| Project Title: | Mission Rock Energy Center |
| Document Title: | Data Request Responses Set 1 & 1A to Data Requests 1 through 114 |

Responses to California Energy Commission Staff
Data Requests 1 through 114

Mission Rock Energy Center

Figure DR34-1a
Areas With a Slope
Greater Than 25 Percent and
Unsurveyed Areas
Mission Rock Energy Center
Ventura County, California

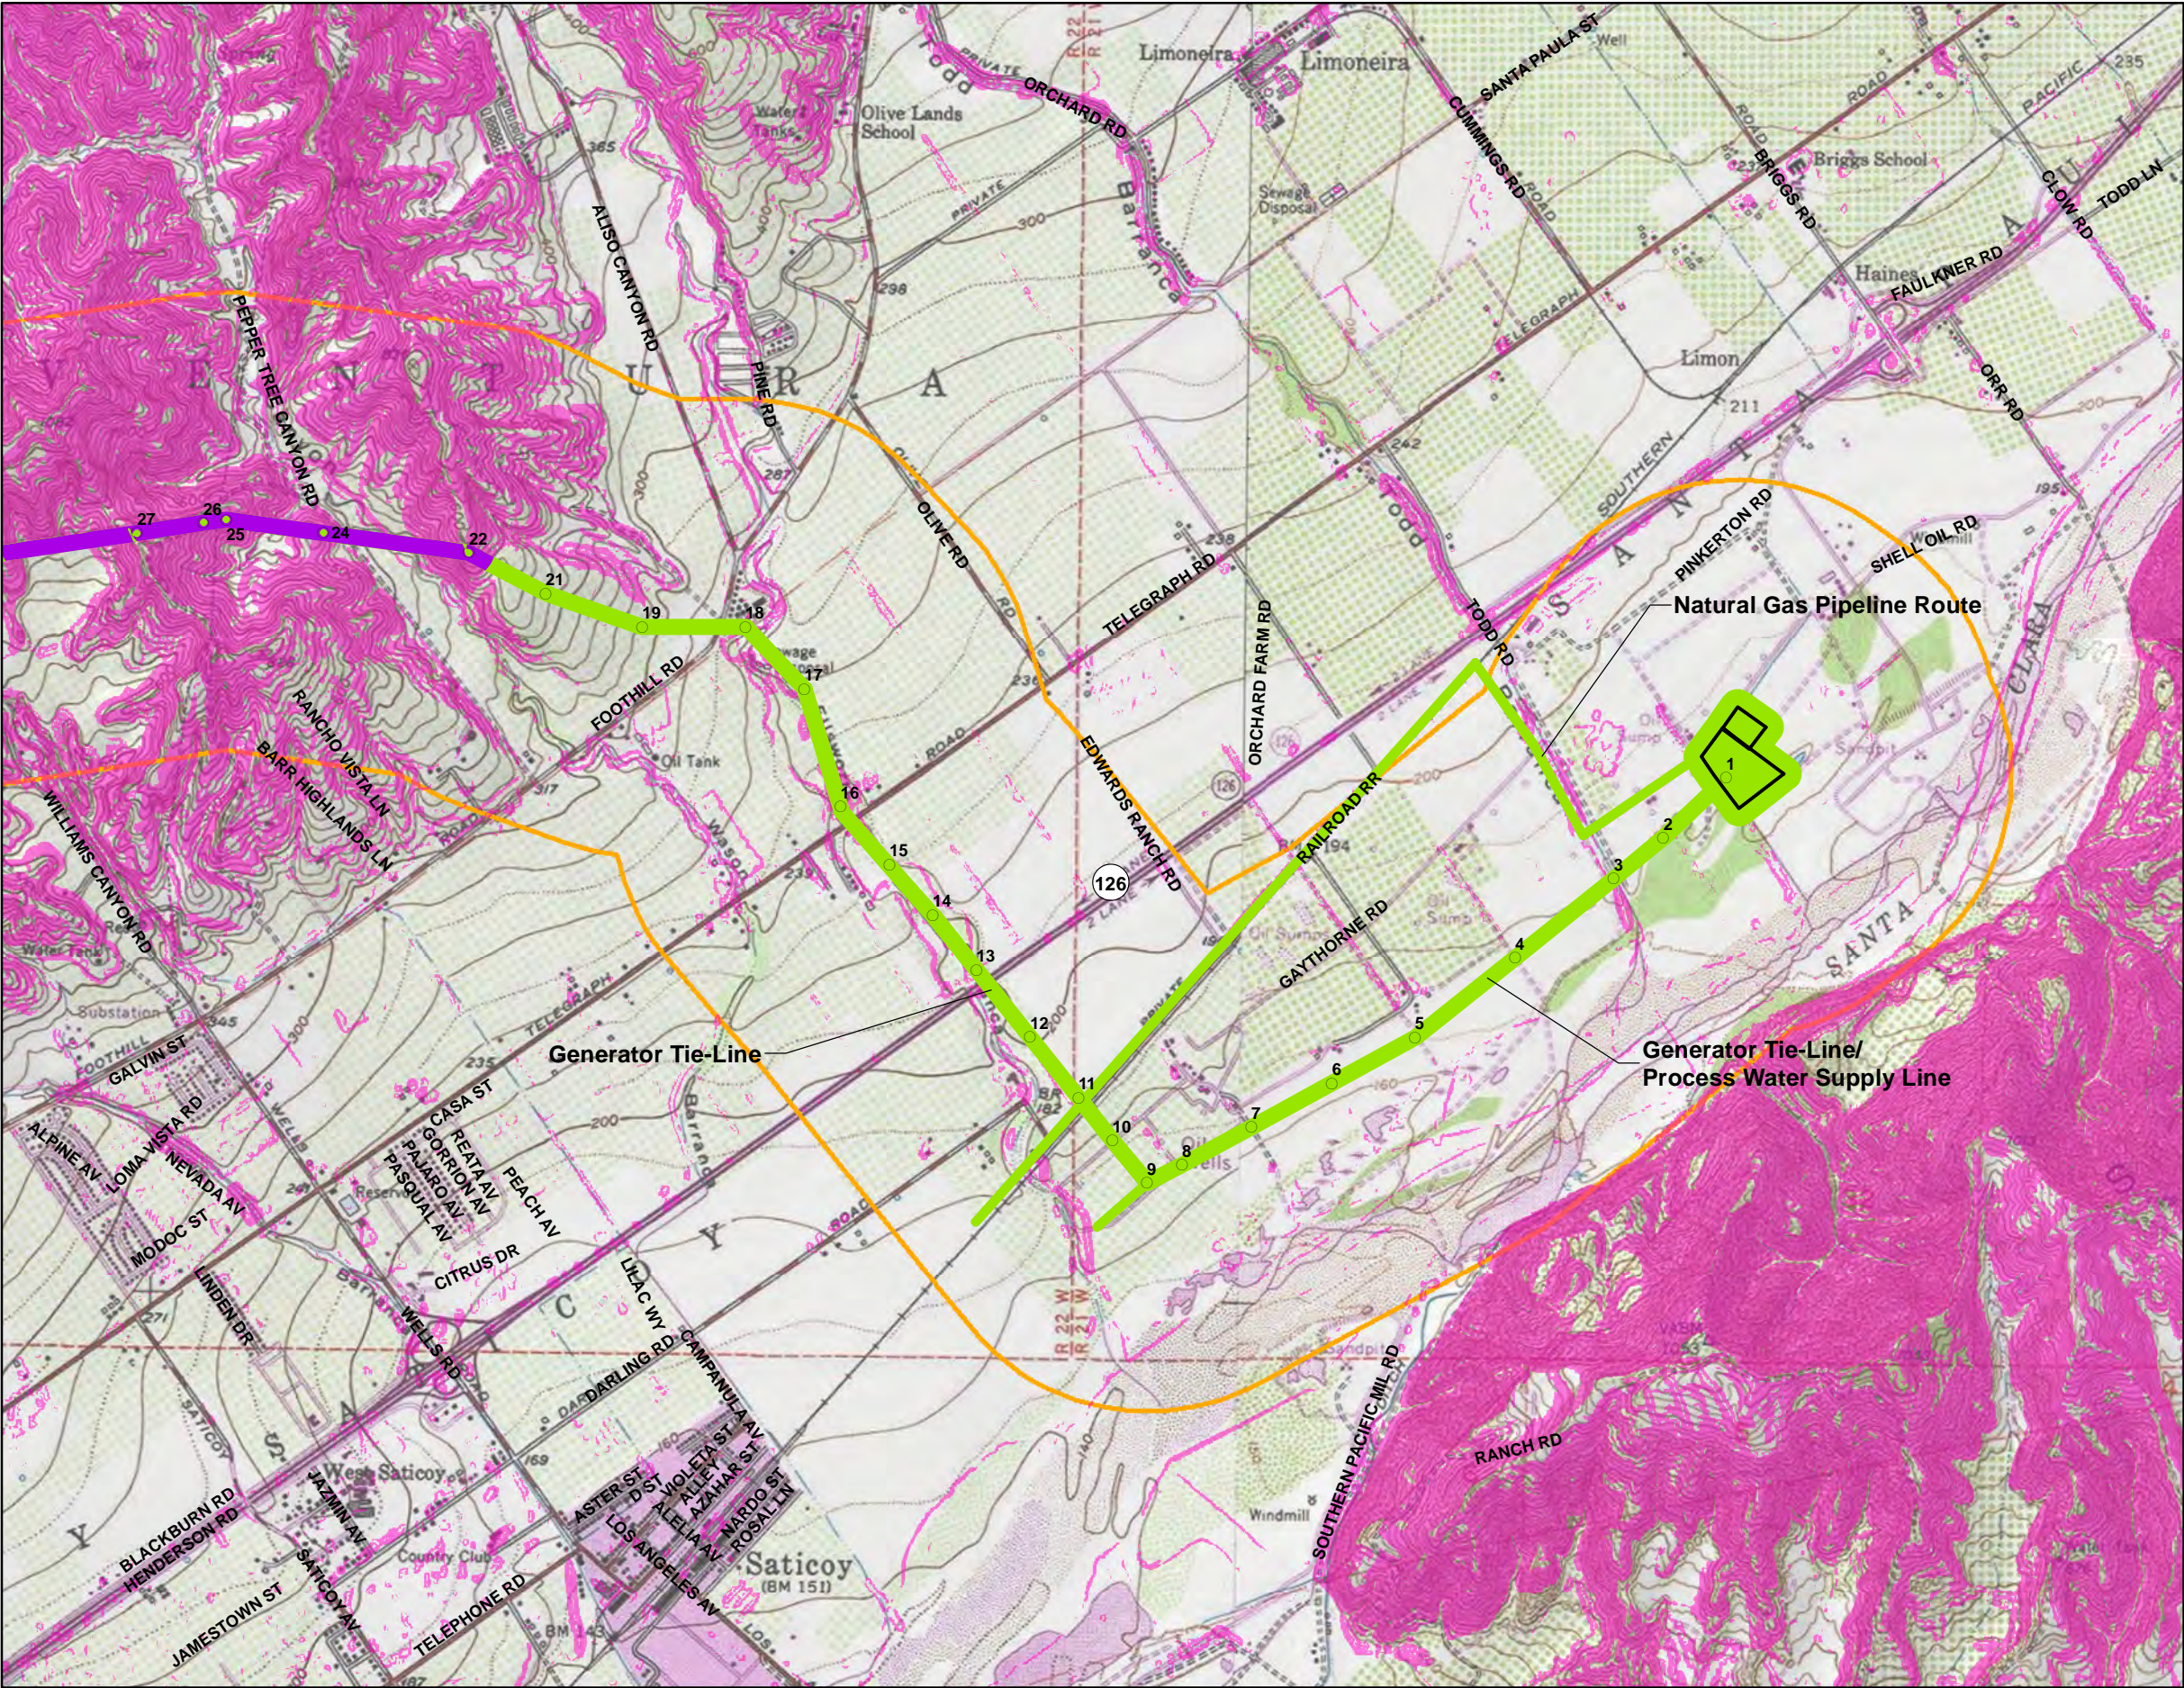
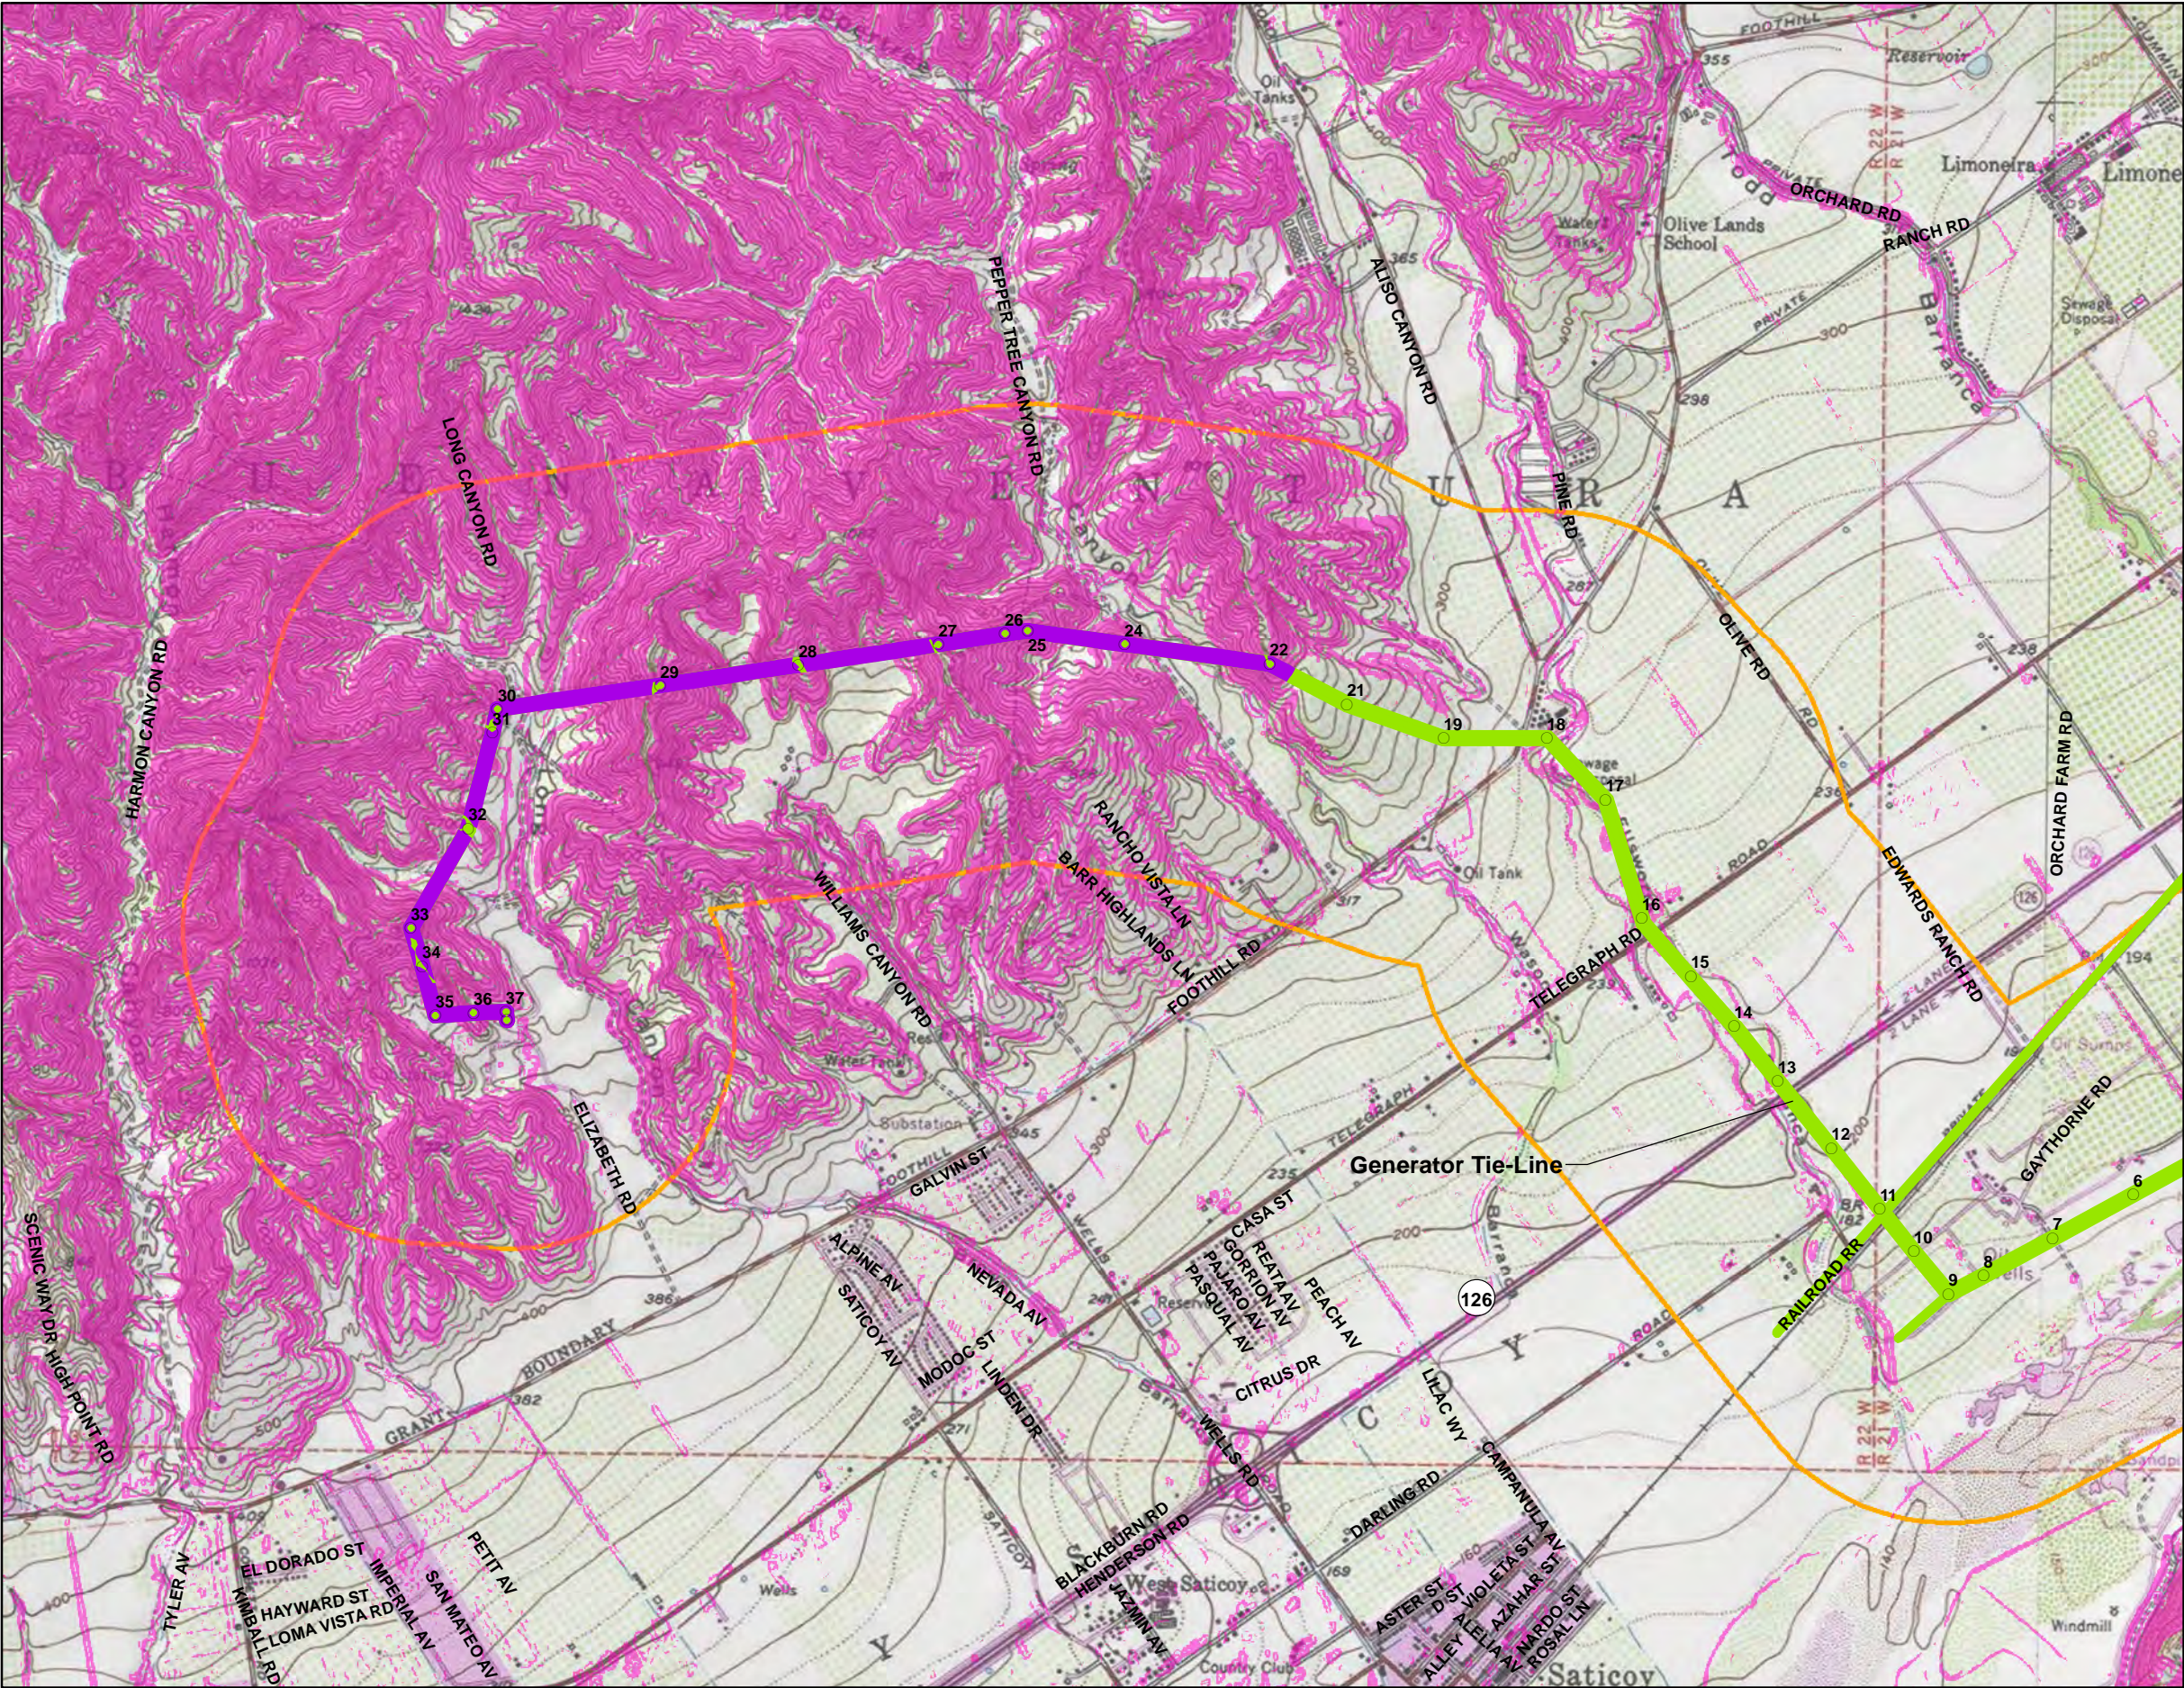
34. *Please provide figures that indicate areas with slope greater than 25 percent and areas that remain unsurveyed in the archaeological resources study area. The figures shall conform to the following requirements:*

Response: Figure DR34-1 shows the areas of slopes greater than 25 percent in the study area. Figure DR34-2 shows the surface visibility throughout the study area.
